Attachment I
Technical Specification Markups

REACTIVITY CONTROL SYSTEMS

ROD DROP TIME

Discussion and Technical Justification

Figure 1

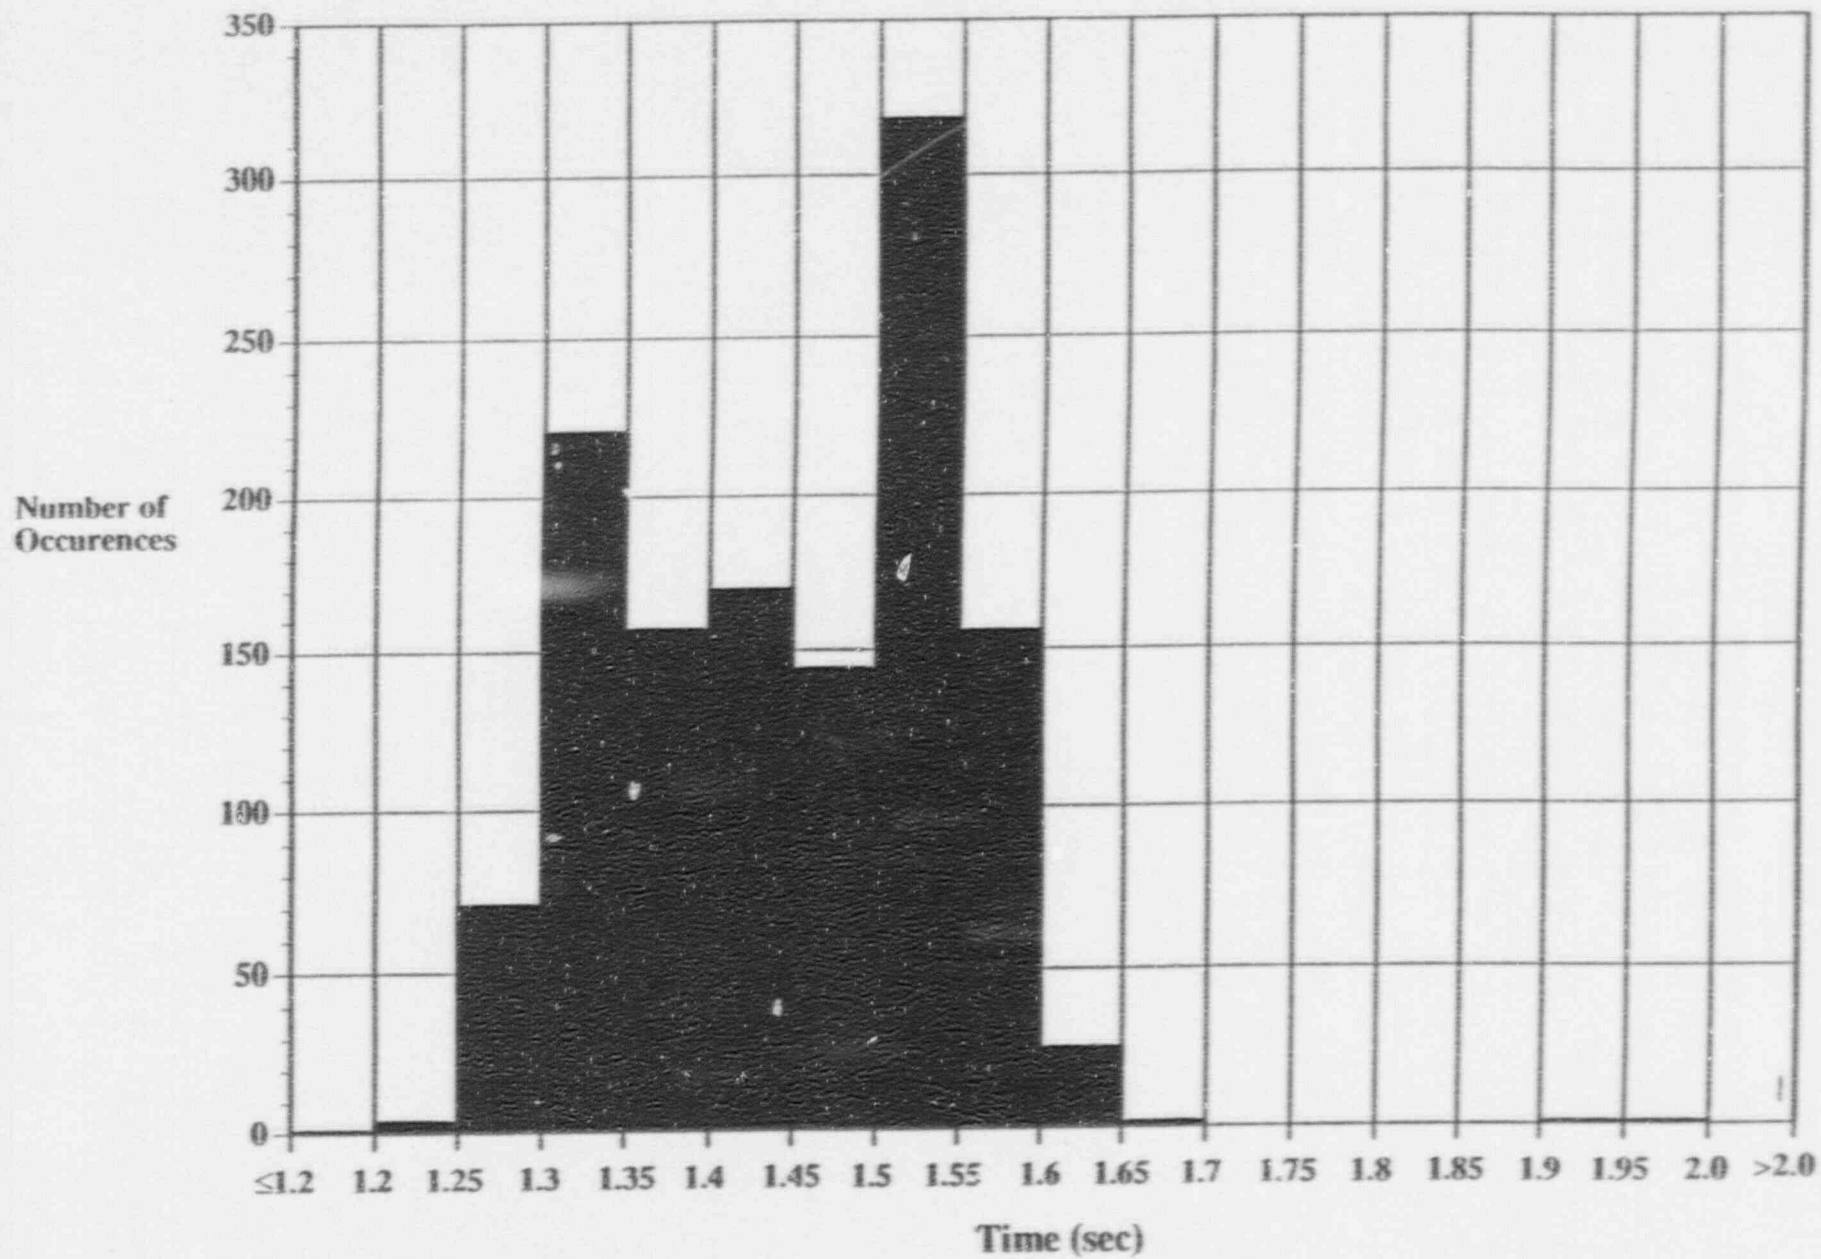
Our experience has shown that the vast majority of drop times at McGuire and Catawba are less than 1.7 seconds. Figure 1 shows the results of drop time testing at all 4 units. Two drops exceeded the design drop time of 1.8 seconds, but were still within the proposed TS limit of 2.2 seconds. These somewhat longer drop times were determined to be caused by air in the control rod drive mechanisms. It can be concluded from these data that 2.2 seconds is sufficient to ensure the proper operation of the control rods, and that the plants are fully capable of meeting the more restrictive drop time requirement.
